Access Compliance Report

Public Rights-of-Way

Intersection ID: 45785	Main Street: SUGARBUSH_DR	Cross Street: LONG_HILL_DR	Location: W
ADA ID: 53A6DFDC2183	Ramp Type: PerpDiag	Initial Pass/Fail: Fail	Overall Compliance: No
		Severity Score: 25

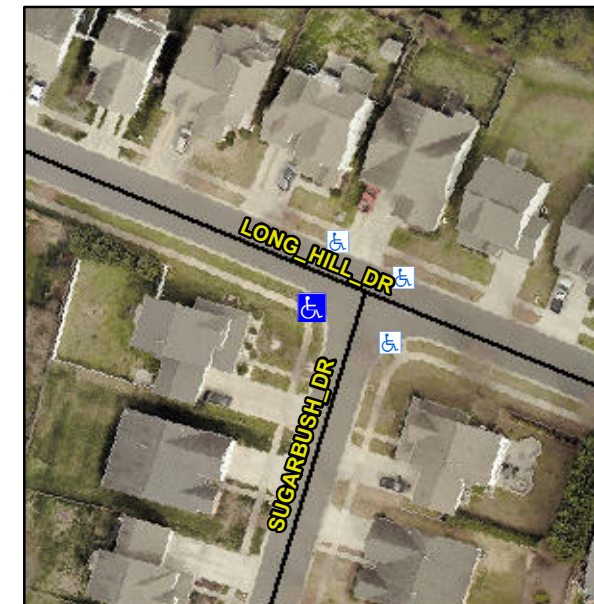
Not Found, R304.5.3

Compliance	Description	Data	Compliance	Description	Data
N/A	Ramp Length (in)	73.0	Yes	Ramp Slope (%)	6.0
Yes	Ramp Width (in)	48.0	No	Ramp XSlope (%)	8.0
N/A	Flare Type LT	N/A	N/A	Flare Type RT	N/A
N/A	Flare Slope LT (%)	N/A	N/A	Flare Slope RT (%)	N/A
N/A	Flare Traversable LT?	N/A	N/A	Flare Traversable RT?	N/A
N/A	Landing Length (in)	N/A	N/A	DWS Provided?	N/A
N/A	Landing Width (in)	N/A	N/A	DWS Contrast?	N/A
N/A	Landing Slope (%)	N/A	N/A	DWS Length (in)	N/A
N/A	Landing X Slope (%)	N/A	N/A	DWS Full Width?	N/A
N/A	Landing Curb? (Y/N)	N/A	N/A	DWS Offset (in)	N/A
N/A	Shared Landing?	N/A			
N/A	Gutter Ponding?	N/A	N/A	Gutter Slope (%)	N/A
N/A	Gutter Lip Ht (in)	N/A	N/A	Gutter X Slope (%)	N/A
N/A	Painted X Walk1?	No	N/A	Painted X Walk2?	No
	X Walk 1 Direction	To SE		X Walk 2 Direction	To NE
N/A	X Walk 1 Width (in)	N/A	N/A	X Walk 2 Width (in)	N/A
	X Walk 1 Slope (%)	2.2		X Walk 2 Slope (%)	4.6
	X Walk 1 X Slope (%)	5.5		X Walk 2 X Slope (%)	0.9

Remove & Replace Curb Ramp With Two New Directional Ramps or Equivalent.
